### 龍門計劃國外製造機械、儀電設備製程中品質查驗

服務機關：台灣電力公司核能安全處

1. 龍門計畫 MS026 「Large Rubber Expansion Joints」採購案，採購合約為 8749011M02600，採購規範為 Specification No. 874-MS-026 Amendment 3, Rev. 0，Quality Class 為 R。本採購

**台灣電力公司 龍門施工處**  
**TPC LUNG MEN CONSTRUCTION OFFICE**  
**不符合報告**  
**NONCONFORMANCE REPORT (NCR) NCR-TGD-451**

DETAIL "B"

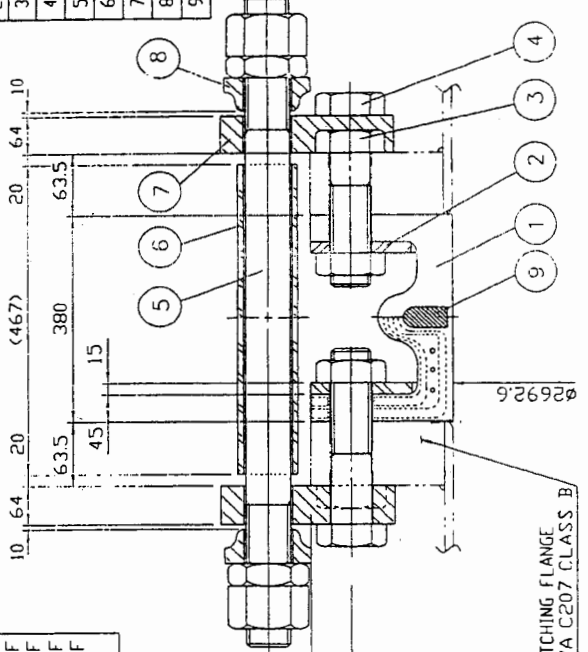
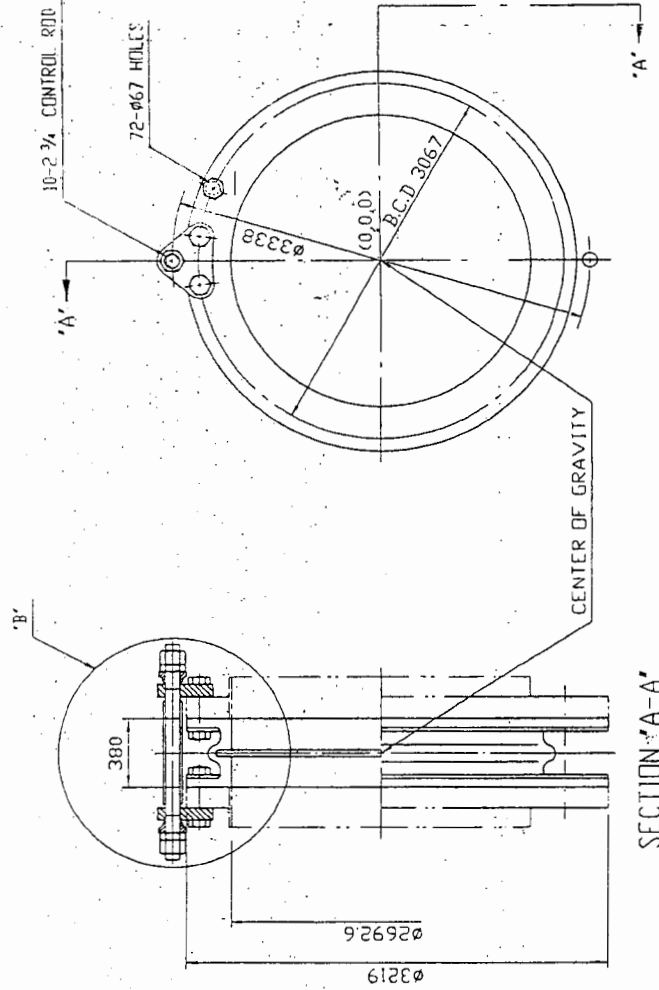
- We found some dimensions of "Face-To-Face Length" were over the tolerance. (attachment 1)
- According to the reference documents (attachment 2), the tolerance should be +1/4 to -5/16 inch.
- We found many defects and damage on the rubber surface. (attachment 3)
- "Ball Seat" and "R/Ring" have oxidized and rusted. (attachment 4)

VALIDATION (1) We need to compress or extend the expansion joints to fit the required dimension when installation. It will cause internal remained stress. (2) We think it may be difficult to install the equipment without leakage due to the dimension problem. (3) When operation, leakage and material failure may occur because of rubber damage. Besides, extra force may cause stress exceed their ultimate stress and result in material failure.

3. As to shown in the Reference 1 Attachment 1, the face to face lengths are not same among No.1 thru No. 6, so each joint's two flanges are not in parallel before installation. Do we need to check angular alignment or parallel alignment (referring to Fig. 1.88 & 1.89, Enclosure 2 for reference) in the installation between the joint's flange and pipe flange? If the answer is "Yes", please tell us the allowable maximum values accordingly.

**Attachment 3**

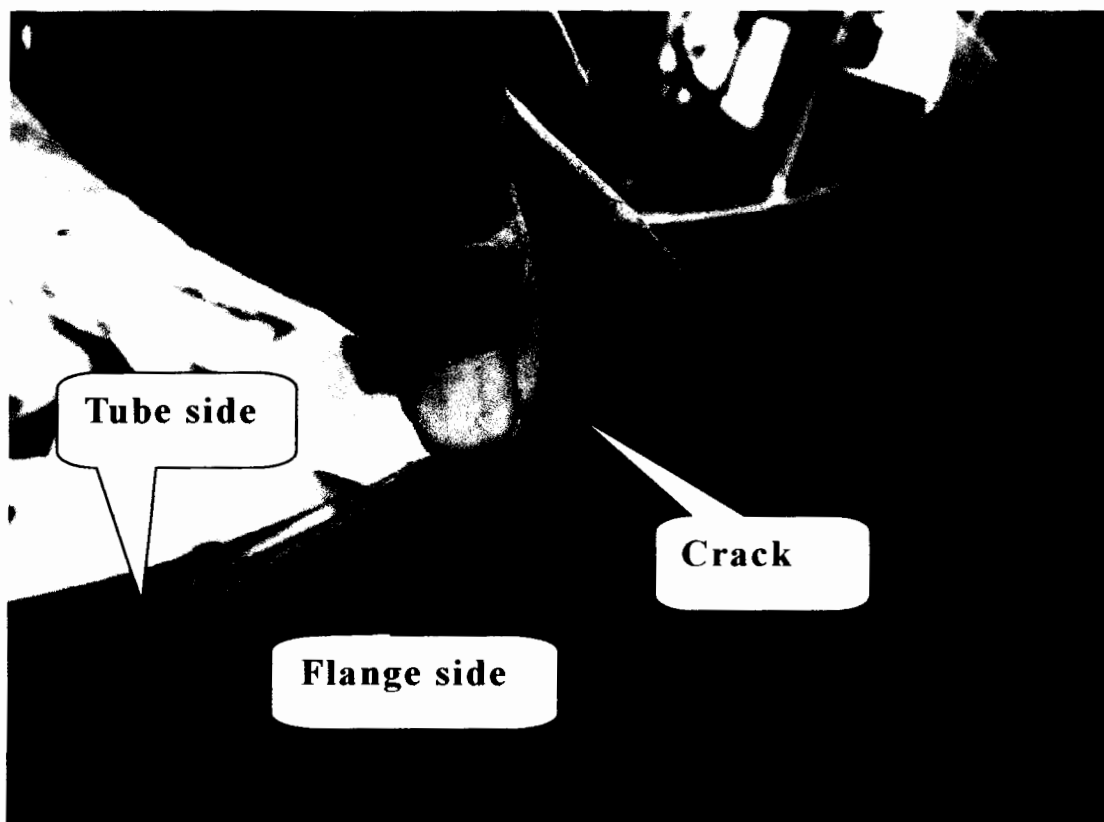
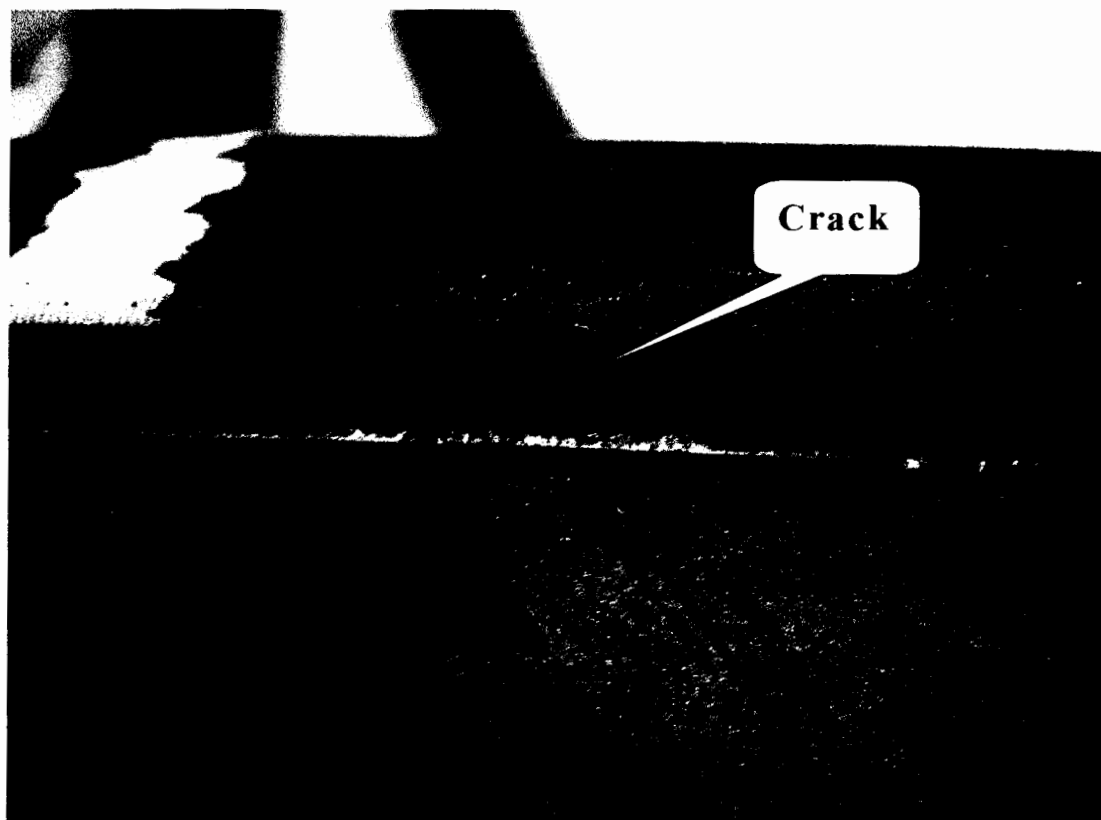
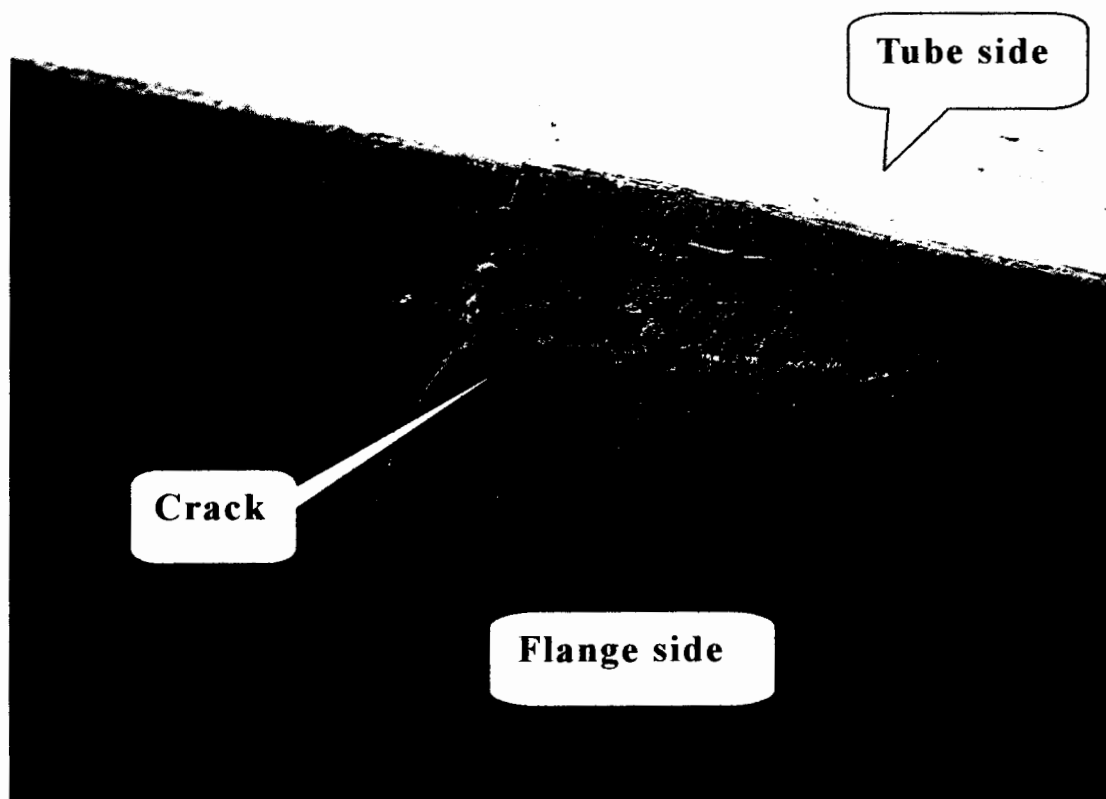
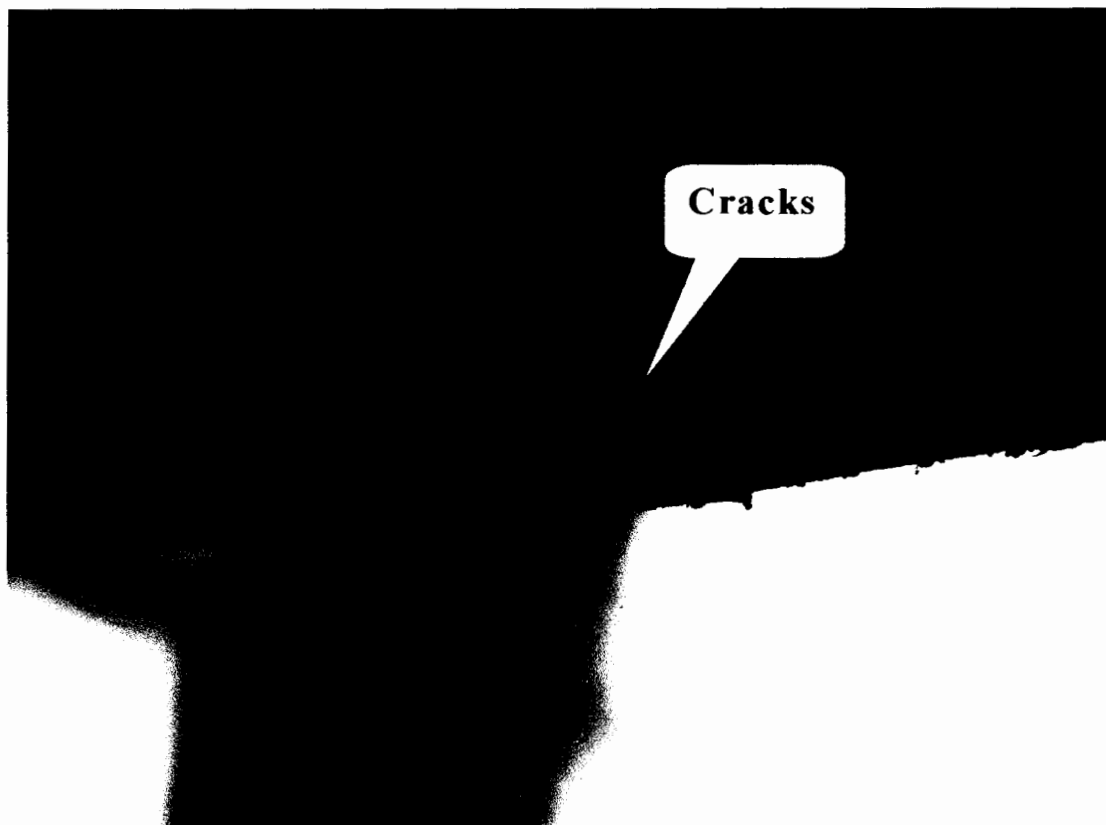
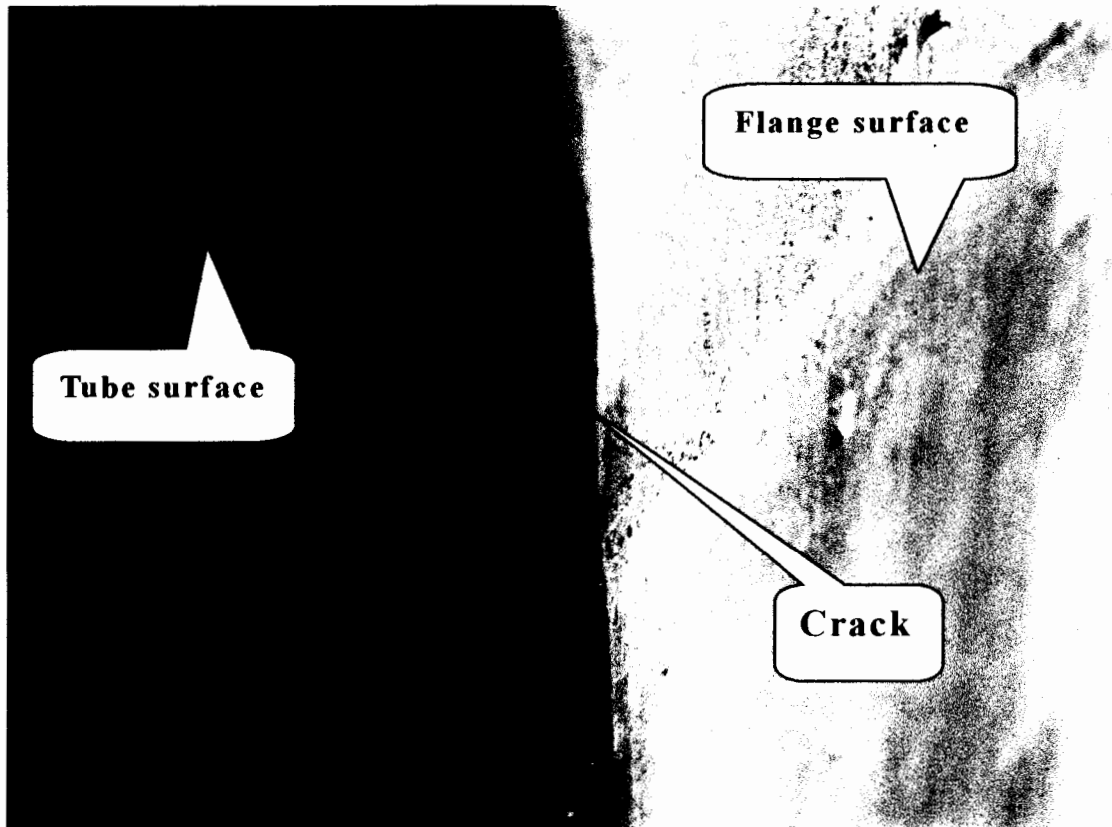
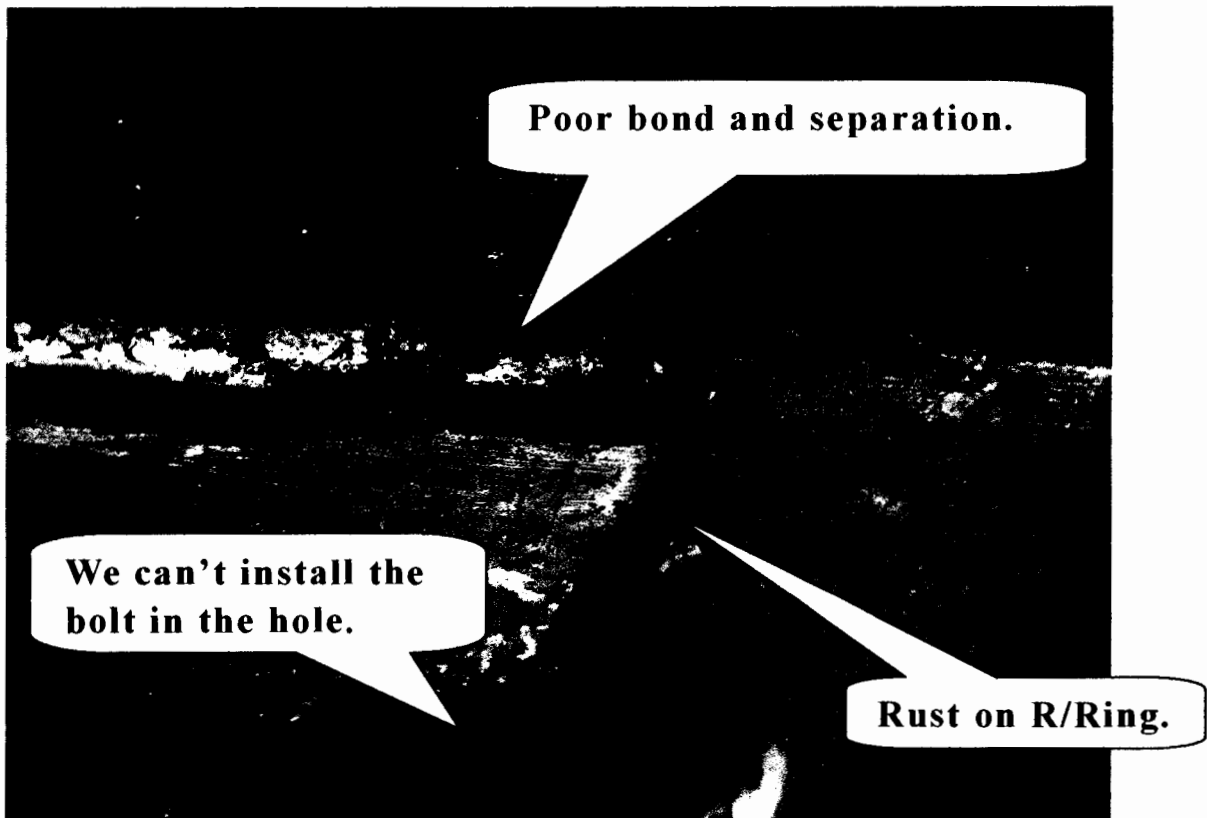
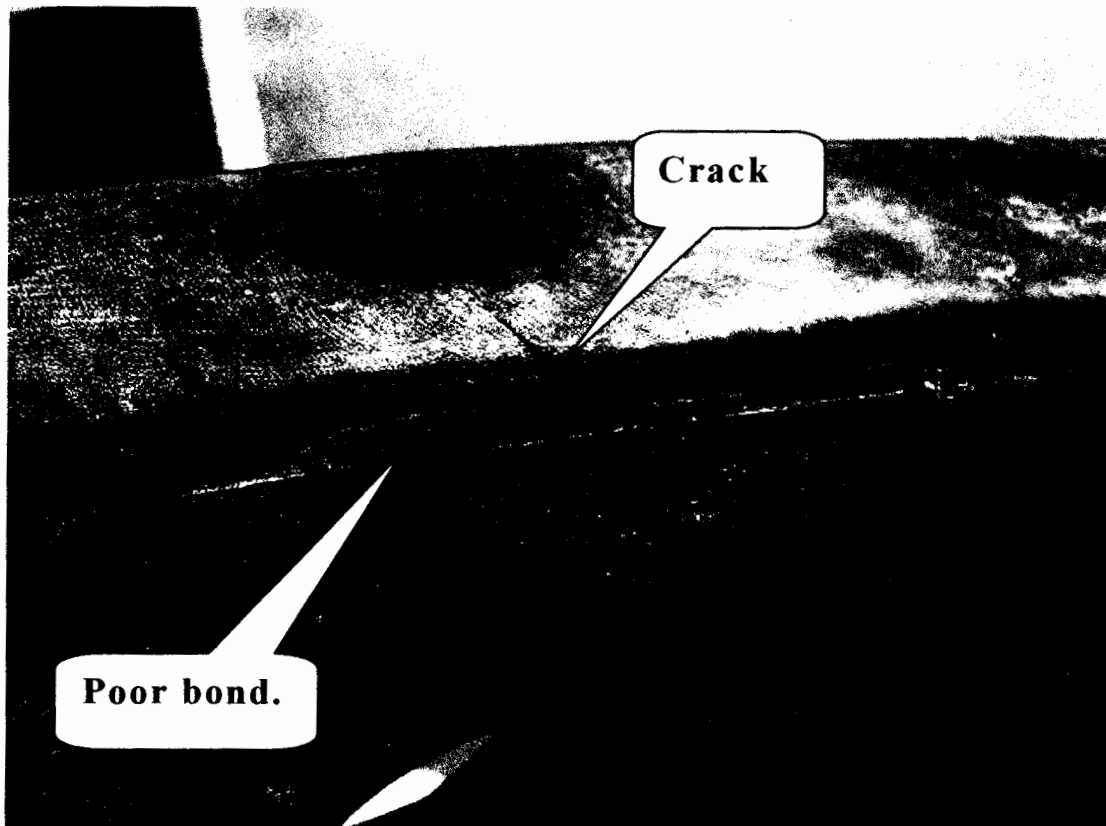
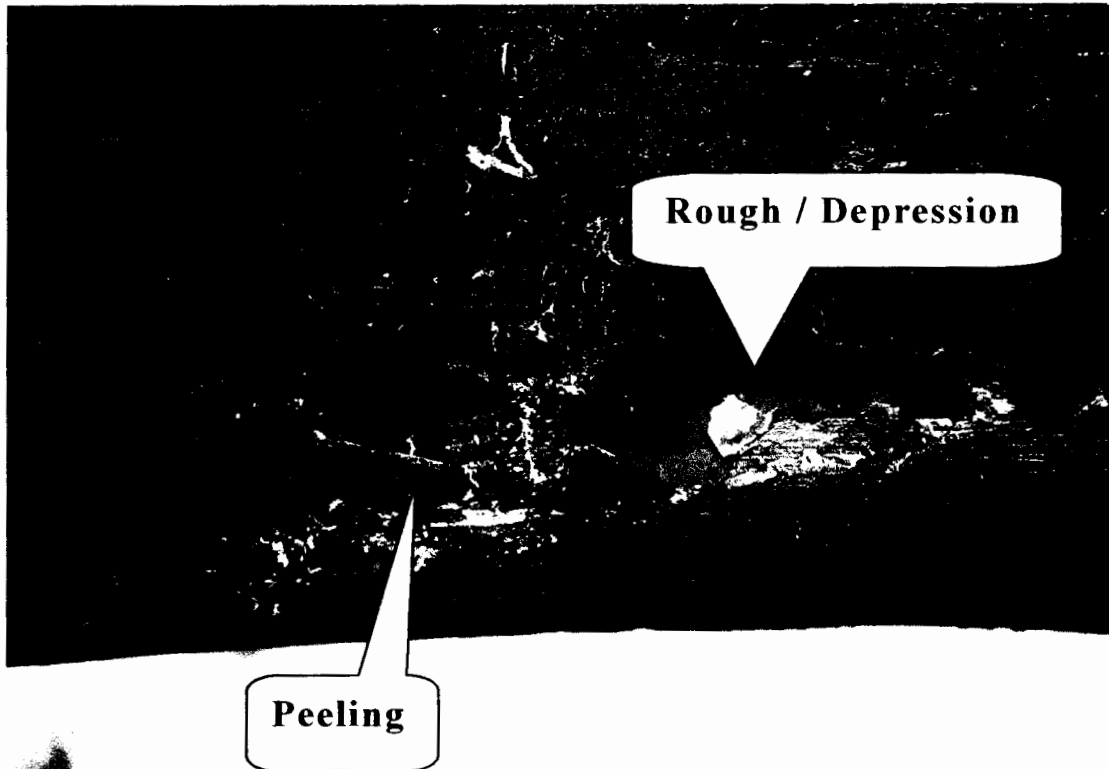
**Crack on flange surface near the tube.**

**Crack on the flange rim.**

**Crack on flange surface near the tube.**

**Damage/ Cracks on flange surface.**

**Cracks in bolt hole.**

**Crack on tube near the flange surface.**

**Damage on tube surface.**

**Rust on R/Ring./ Poor bond and separation between R/Ring & Body.**

**.Poor bond between R/Ring & Body.**

**Crack / Poor bond between R/Ring & Body.**

**Rough and peeling on flange surface.**

**Crack in bolthole. It shall be sealed to completely cover the carcass fabric.**

**Damage on flange rim.**

**Peeling on flange surface near the tube.**
